Request for Information – Local Government Official Information and Meetings Act 1987

Subject Tupua Horo Nuku North – Atkinson Tree Options

Reference NKP-TAT-THN-MEM-CV-NS-000001

Figure 6 - Plan of Realigned Road and Path

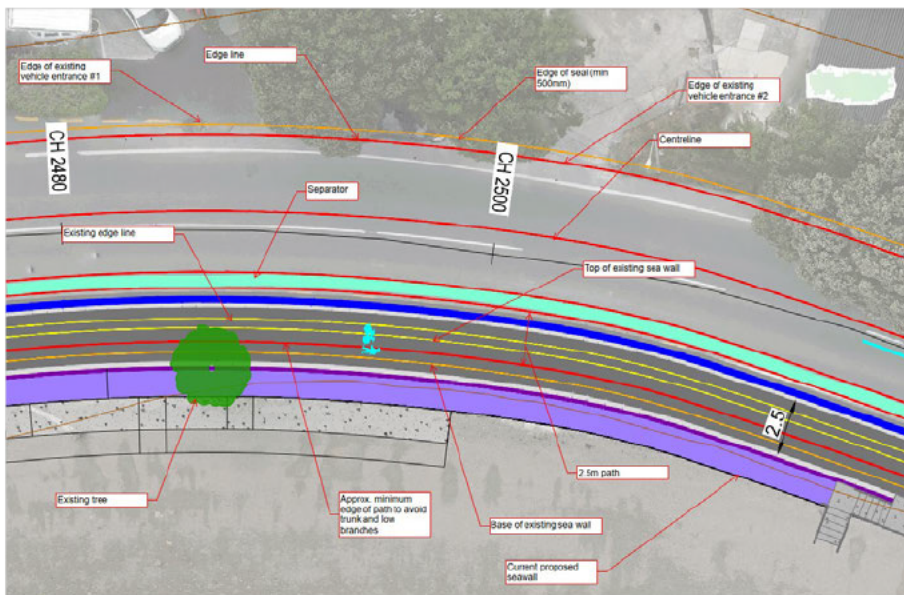
Commented [MF3]: Is that the new ramp location? Just want to make sure it is.

Commented [AG4R3]: Yes it is. Will account for this in my sketch in Section 3.1. This part will be covered by sand after beach nourishment.

Figure 12 Indicative cross section showing relocation of the Atkinson tree within the beach. Not to scale

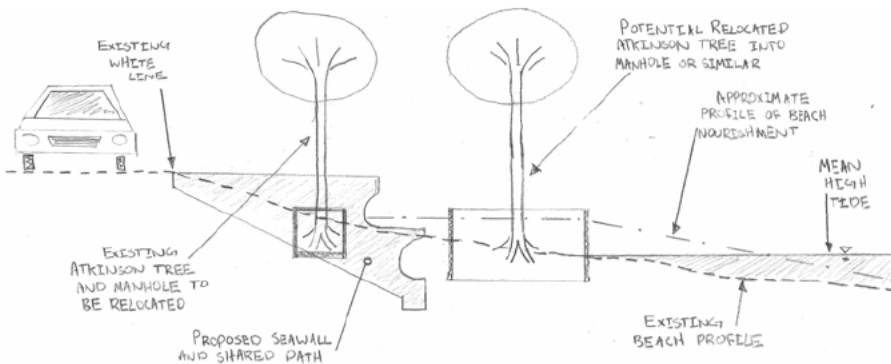
Commented [MF23]: Update section - too technical. A hand sketch of the same will tell a better story for the intended audience.

Commented [AG24R23]: See updated image
